DETAILED ACTION

In view of the appeal brief filed on October 7, 2010, PROSECUTION IS HEREBY REOPENED. Rejections are set forth below. To avoid abandonment of the application, appellant must exercise one of the following two options:

Art Unit 1776

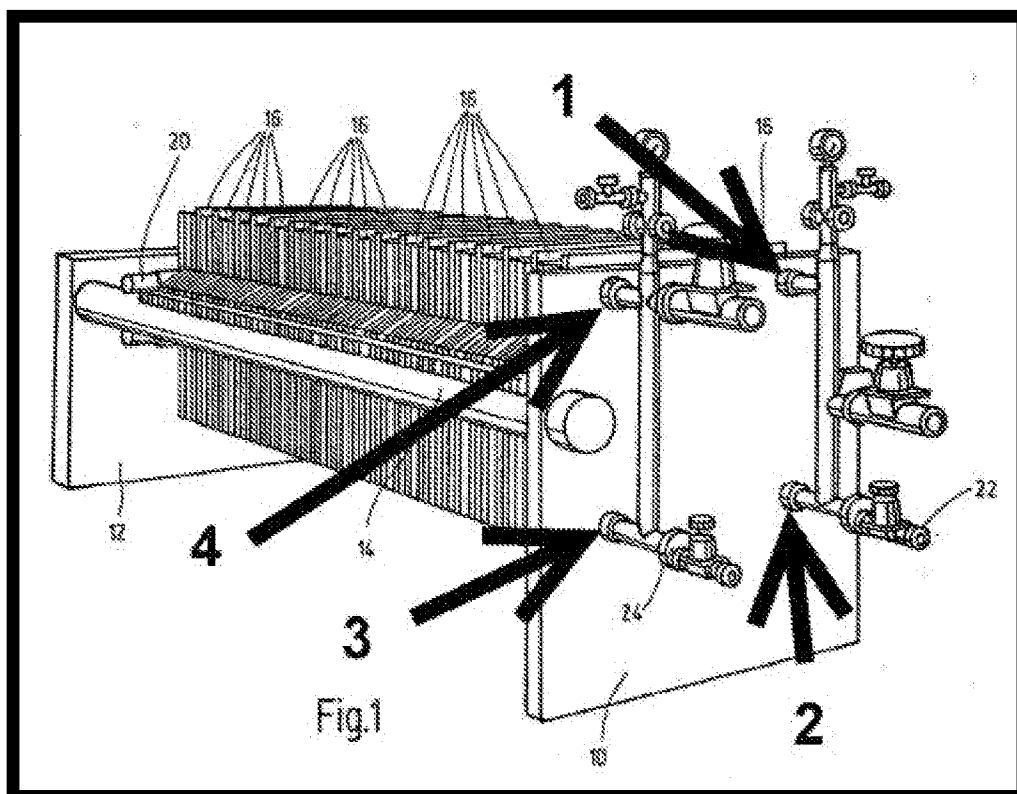
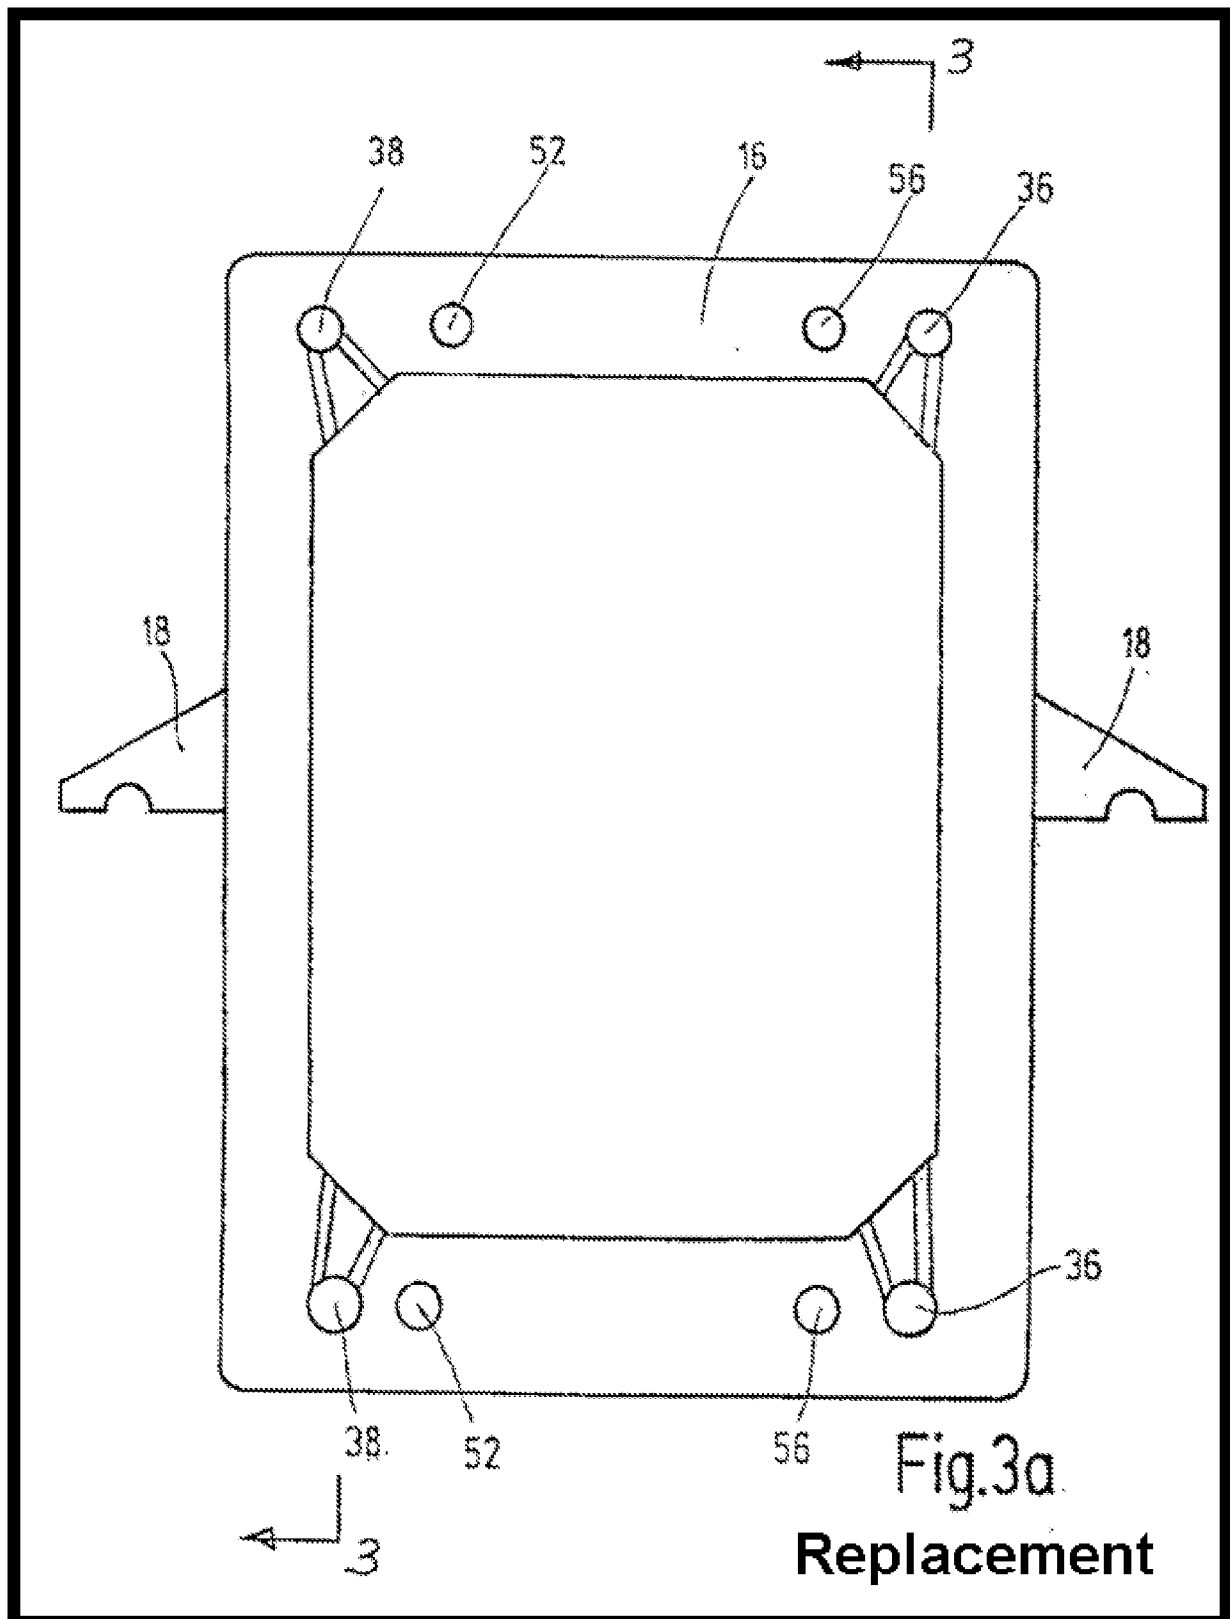
Applicant has failed to teach those skilled in the art how fluid communication between the **FOUR** unlabeled ports (see annotated Figure 1 below) in “**mounting plate**” **10** and the **EIGHT** orifices/ports (**38, 52, 56** and **36** in the top; **38, 52, 56** and **36** in the bottom) in the **frame 16** of **Figure 3a** takes place.

As depicted in **Figure 1**, **frame 16** is pressed against "**mounting plate**" **10**. It is unclear from the disclosure (including and considering those supplemental portions that were added years after the initial filing) how the **EIGHT** ports/orifices of frame 16 of **Figure 3A** fluidically communicate with the **FOUR** unlabeled ports/orifices of "**mounting plate**" **10** as depicted in Figure 1. The disclosure (including and considering those supplemental portions that were added years after the initial filing) fails to teach how these ports/orifices communicate with each other. For this specific technical reason, one skilled in the art would be unable practice the invention without undue experimentation.

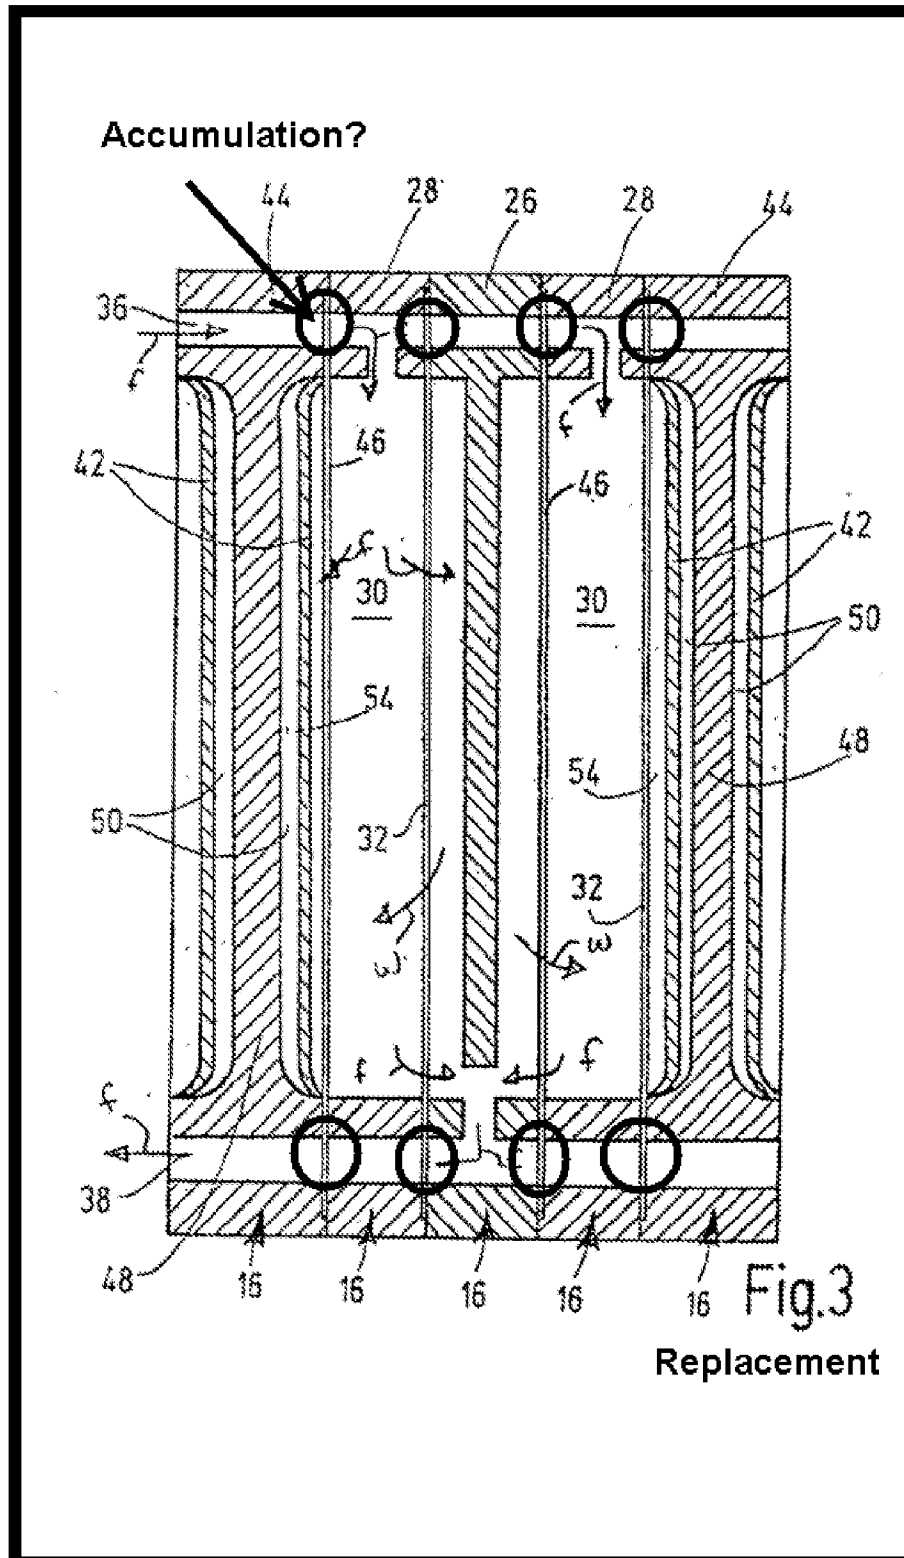
Additionally, it is unclear how pressure spaces 52 and pressure spaces 50 communicate with other volumes or spaces within the system. Applicant points to non-elected **Figure 4a** in his brief, asserting:

It is unclear why the same “**connecting passages**” do not appear in Figure 3a. Does the depiction in **Figure 3a** present a different construction, or an erroneous one, when compared to **Figure 4a**? But this reference to **Figure 4a** brings out another point of confusion. If, as shown in **Figure 4a**, the “**output channels**” 38 and 40, the “**input channel**” 36, and the “**pressure channel**” 52 all communicate with the same volume as depicted in **Figure 4a**, then, how is filtration accomplished? What forces the unfiltered material through the filter media? Why would the unfiltered material not immediately go from the “**input channel**” 36 to the “**output channels**” 38 and 40 without passing through any filter?

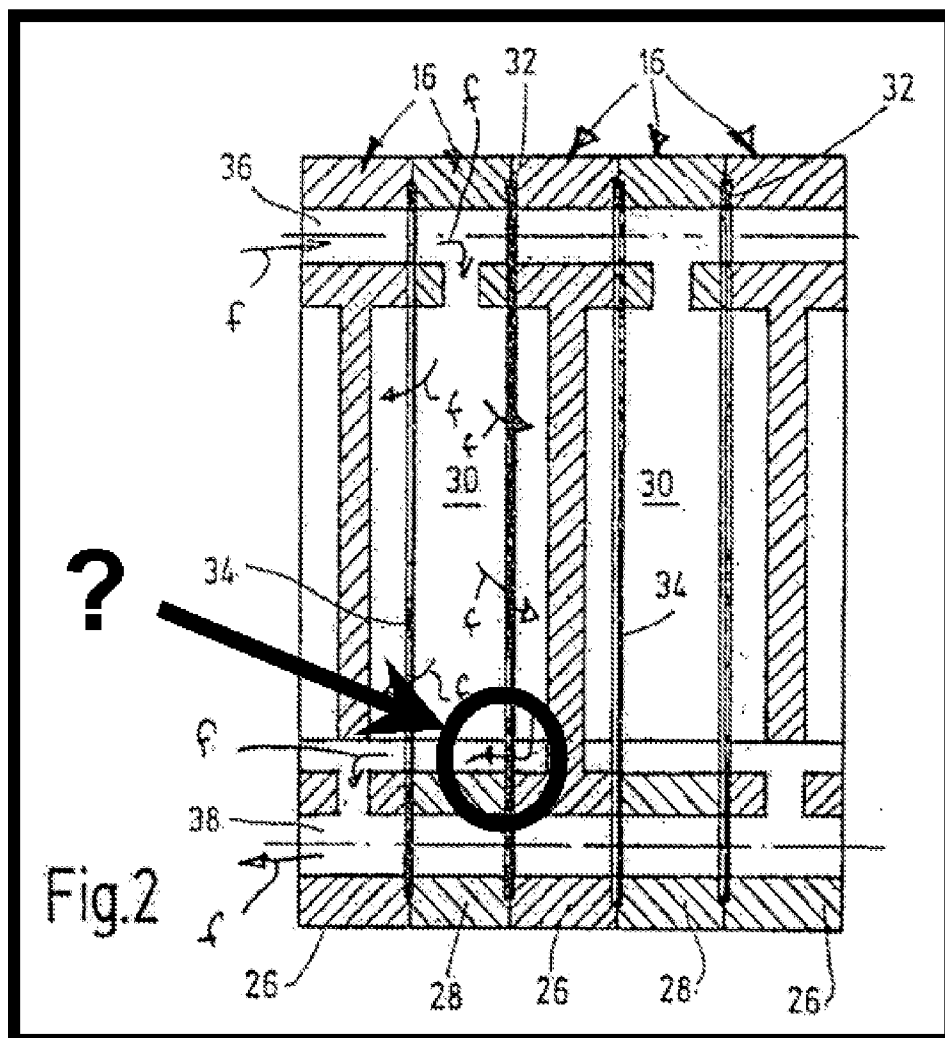
Although non-elected, the filtering flow of the type ***apparently*** depicted in Replacement Fig. 2 (see immediately below) must be addressed, since it has been so often argued and referred to while ***“prosecuting”*** the elected species. According to the filtering flow arrows “f,” after entering chamber 30 through an unlabeled passage, the flow splits, going across laminar filter 34 and alternately across laminar filter 32 into an unlabeled chamber depicting no outlets, and thereafter, passing back across laminar filter 32 again in a lower portion of chamber 30, and then across laminar filter 34 before exiting through yet another unlabeled passage in fluid communication with 38.

Given the instant disclosure, one skilled in the art would not know across, and then back across the same filter 32, takes place, as the structure/means to facilitate such flow has not been clearly depicted or described. No such flow takes place in the elected species depicted in Fig. 3.

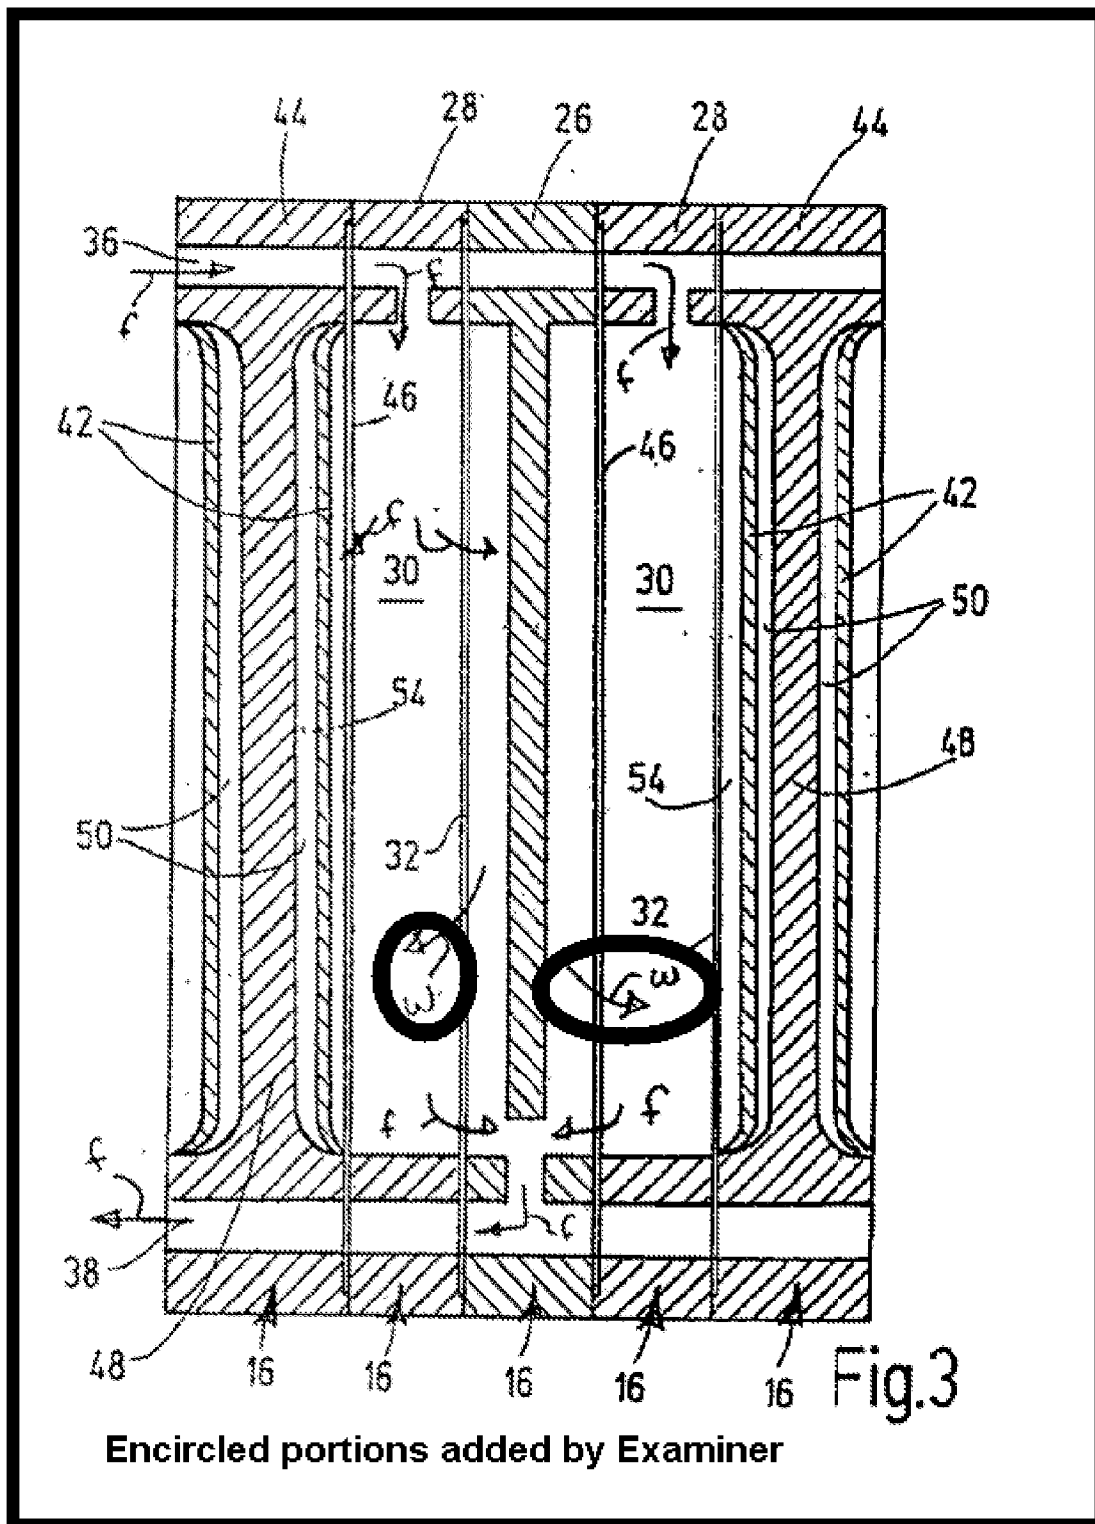
Looking to the replacement drawings submitted on **January 21, 2010**, where labels “**w**” have been added to aid in the understanding of the invention by depicting the “**washing flow**” (Remarks of January 21, 2010; Page 8; lines 8-10), it remains unclear how the wash fluid communicates with the claimed “**output,**” as the arrowhead associated with each added “**w**” ends in a chamber with no apparent outlets at all.

Moreover, it is unclear how the **“washing flow”** emanates from a chamber depicting no inlets.

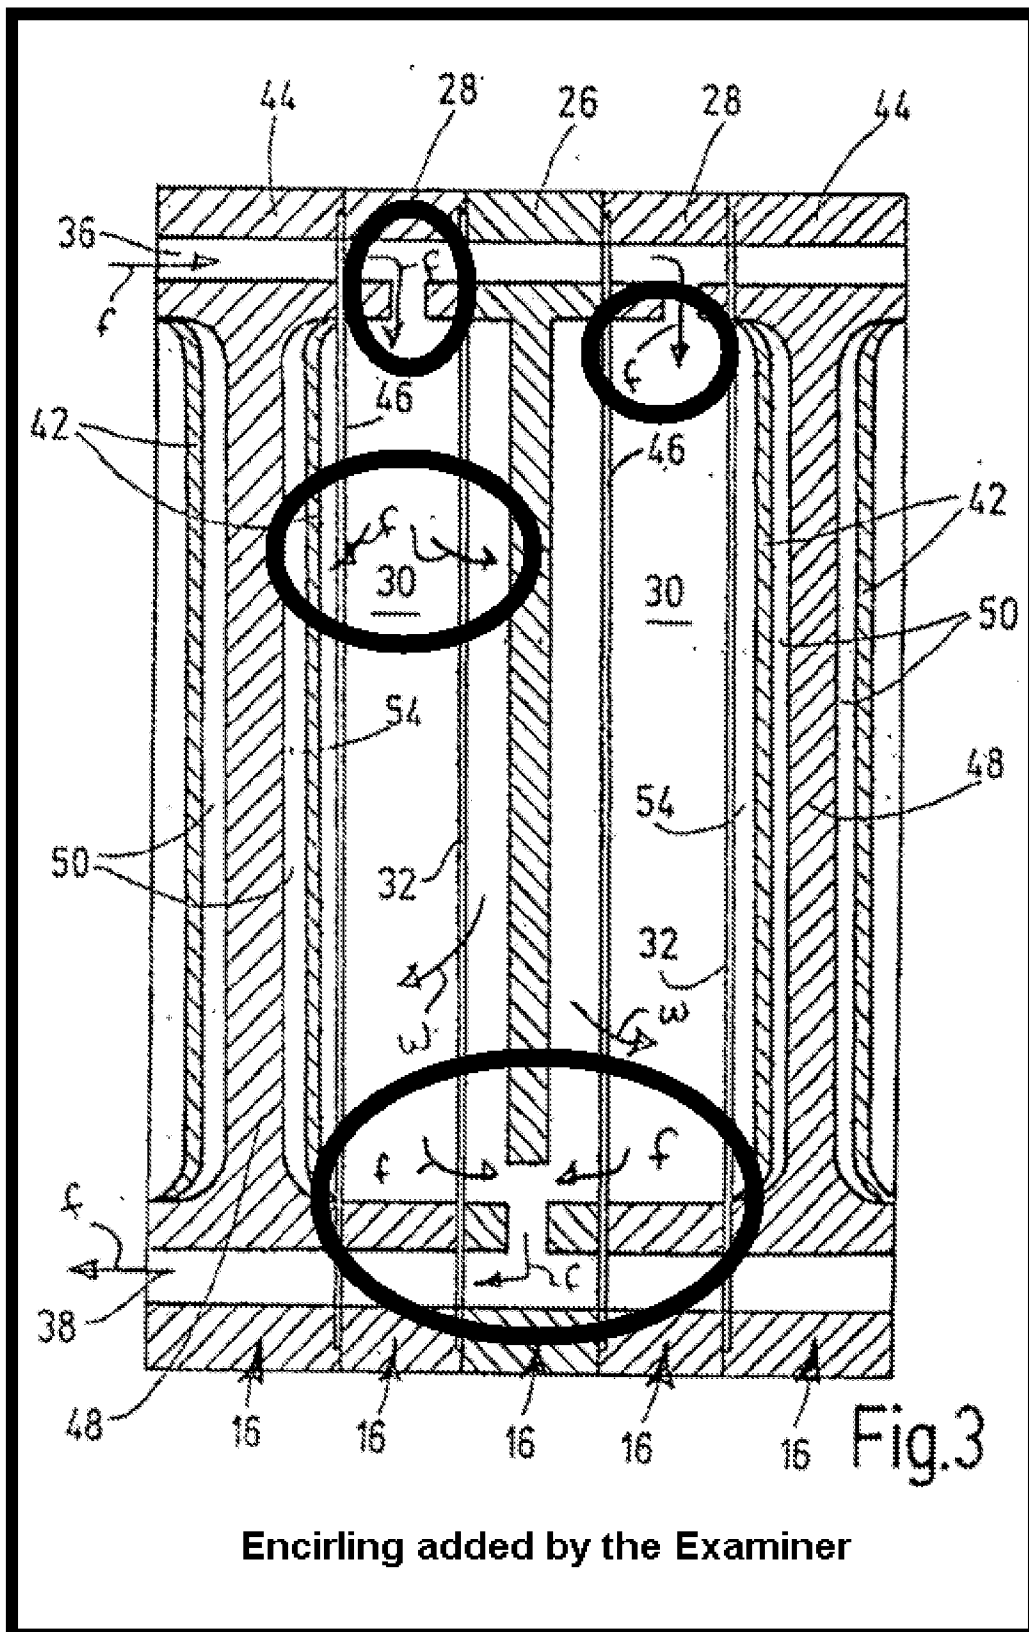
It is noted here that the “**washing flow**” arrows “**w**” depicted in replacement Fig 3 above, appear to be in complete disagreement with what is taught in the specification:
